# ADDENDUM to CONTRACT DOCUMENTS

Project Name: Glasgow High School

**Culinary Kitchen Renovation**

Subject: ADDENDUM 5

A201

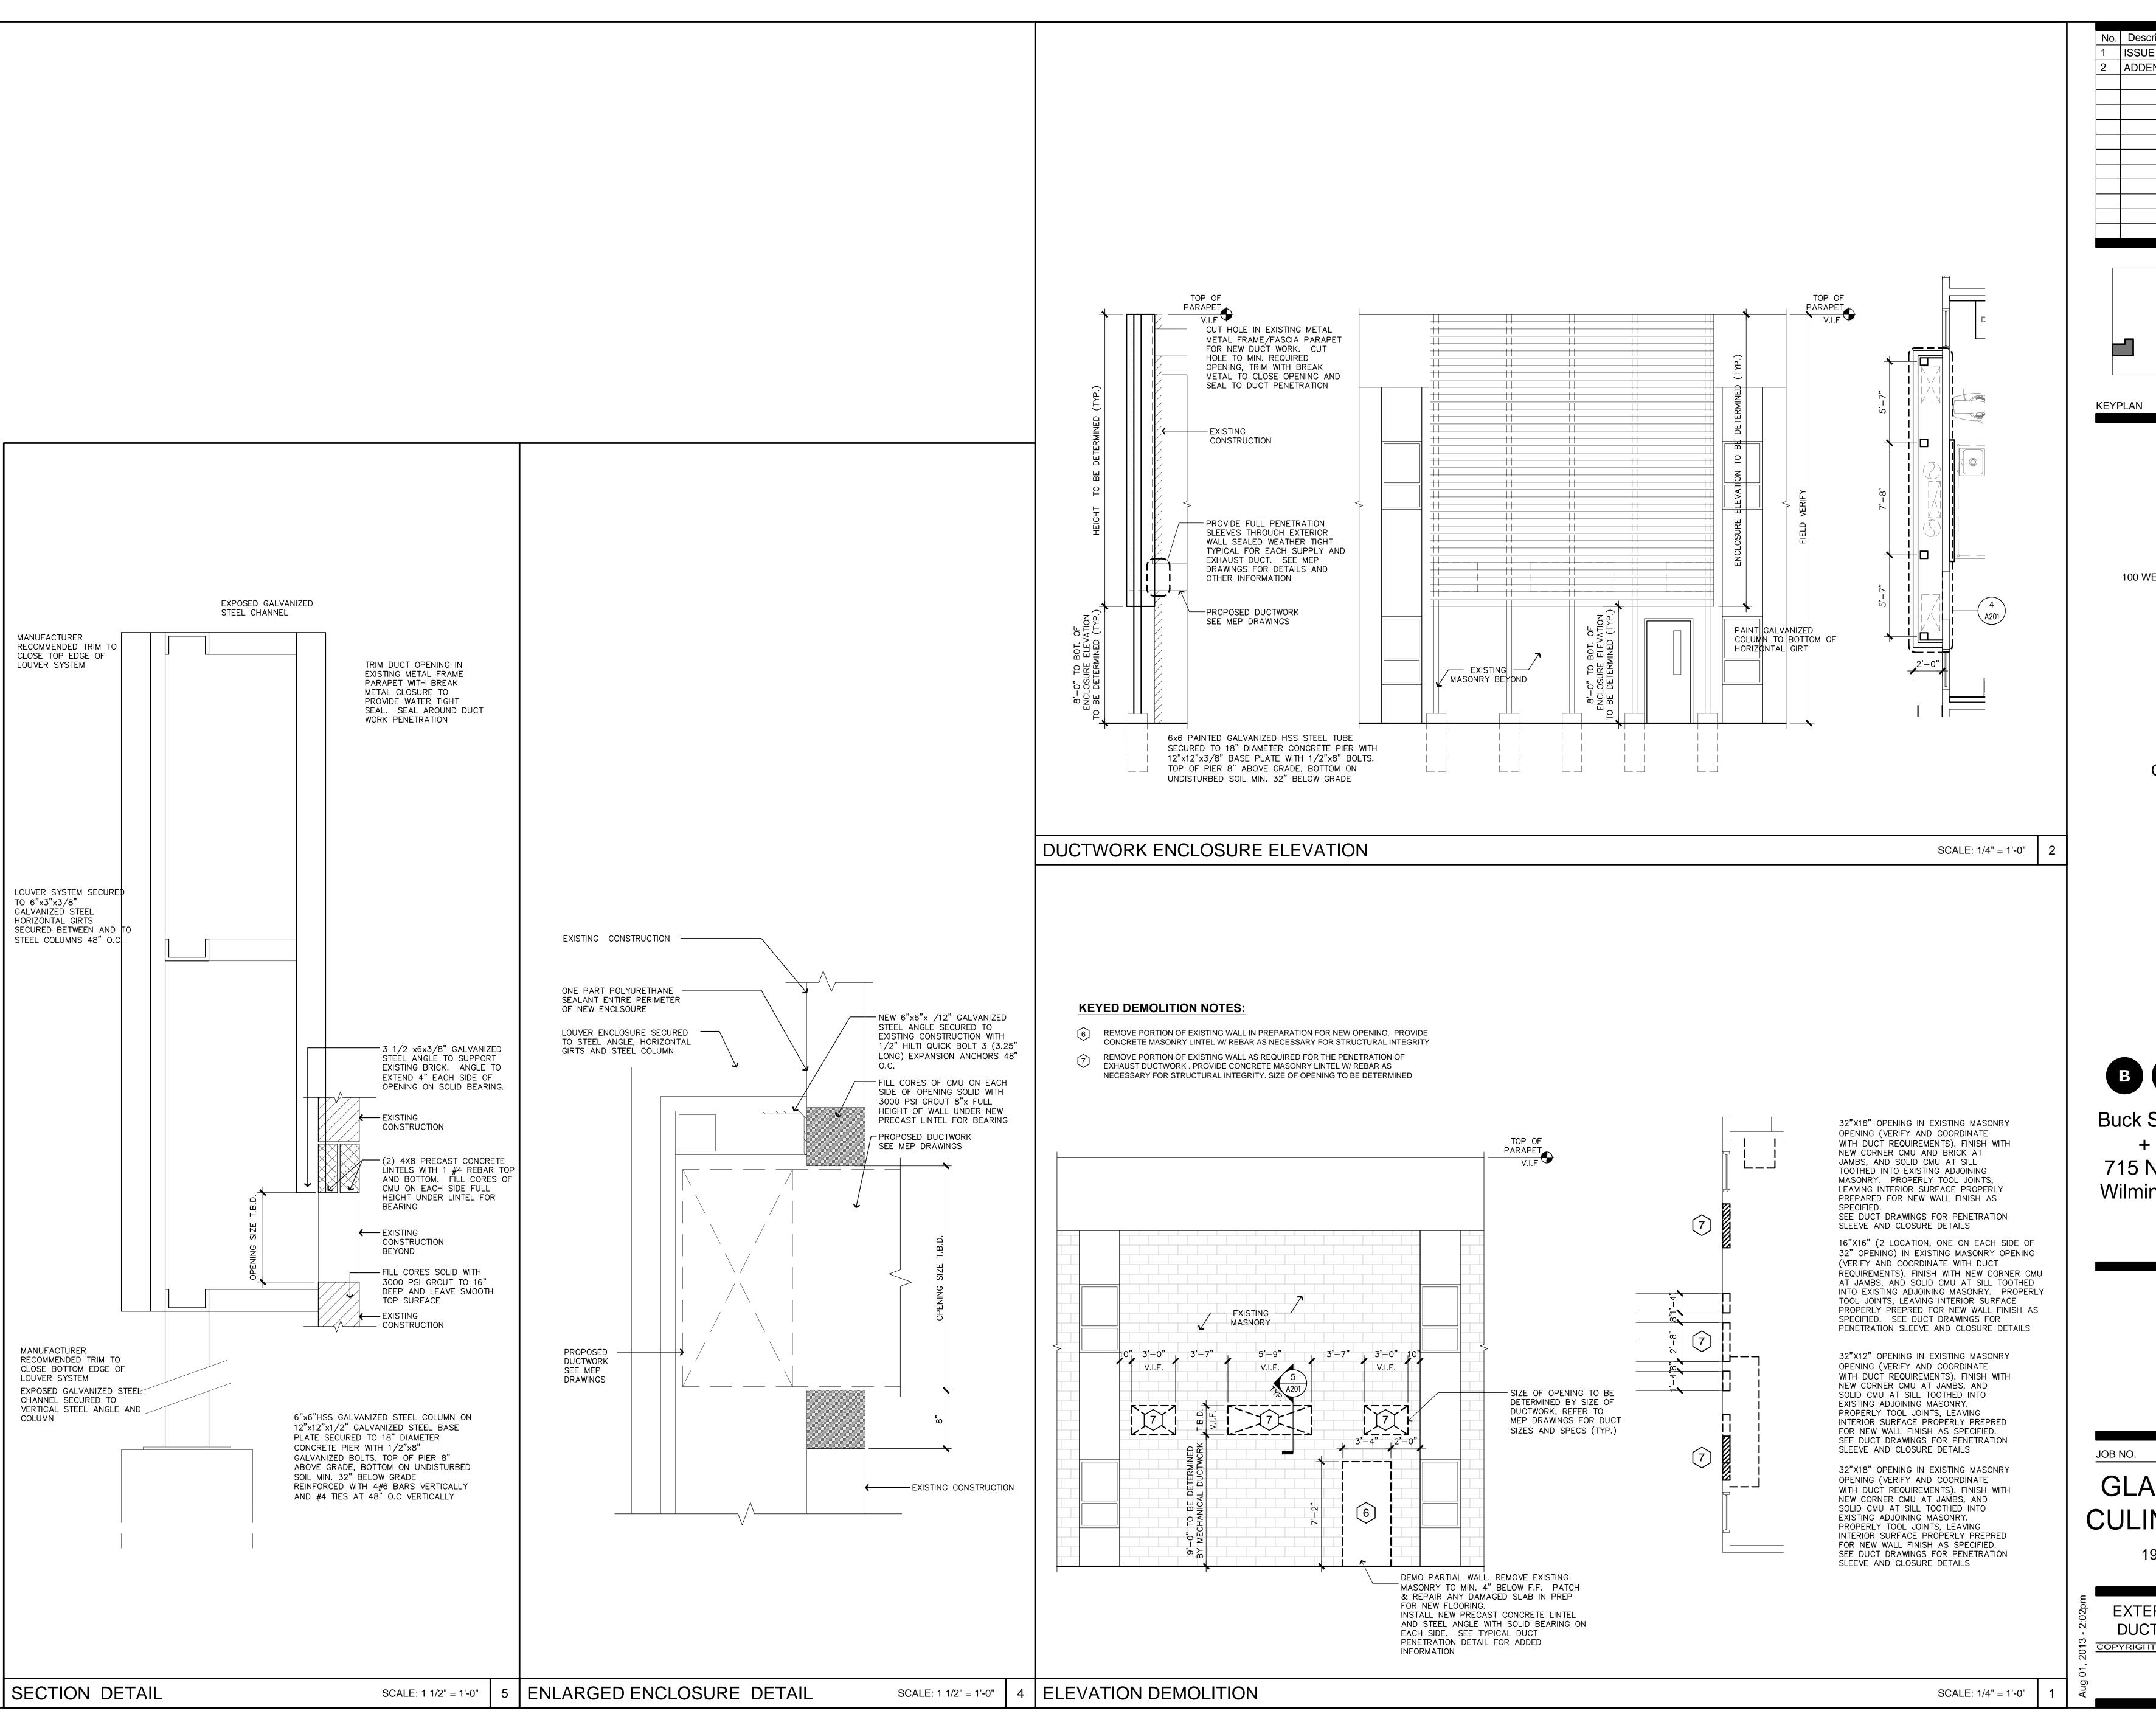
Item No.	Description:
D-1	DRAWING A-201
	Replace with new drawing attached
<b>D-2</b>	Drawing A-311 Door schedule/Notes
	Add as follows:
	Doors 101 and 103 are existing doors, reuse existing hardware in new locations add new wall stops
	Rockwood 403
